Technical Service Bulletin

19 Coolant pipe seepage on turbocharger

19 17 82 2036167/6 March 21, 2017. Supersedes Technical Service Bulletin Group 19 number 16-76 dated December 6, 2016 for reasons listed below.

Model(s)	Year	VIN Range	Vehicle-Specific Equipment
A8, S6, S7, S8, RS 7	2013 - 2017	All	4.0 T

Figure 1. Black, encrusted coolant residue (outlined area), coolant feed pipe (A), oil feed pipe (B), and coolant return pipe (C).

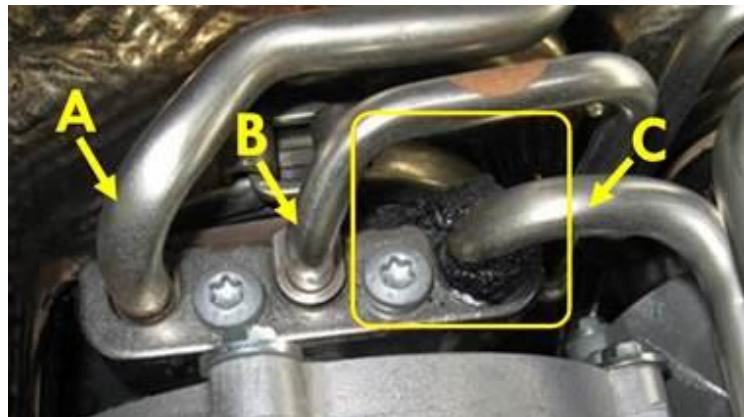
There may be slow coolant loss from the connections at the coolant feed pipe and the coolant return pipe. High temperatures cause the coolant to become encrusted on the connection flange of the turbocharger (Figure 1).

The resulting heat after switching off the engine can, under special operating conditions, lead to very high temperatures on the coolant seals of the turbocharger. This can damage the O-ring.

Optimized temperature-resistant O-rings on the coolant connection of the turbocharger together with an extended operating period of the auxiliary cooling pump after switching off the engine.

Replace the respective O-rings on the coolant supply and return pipes according to the table listed below:
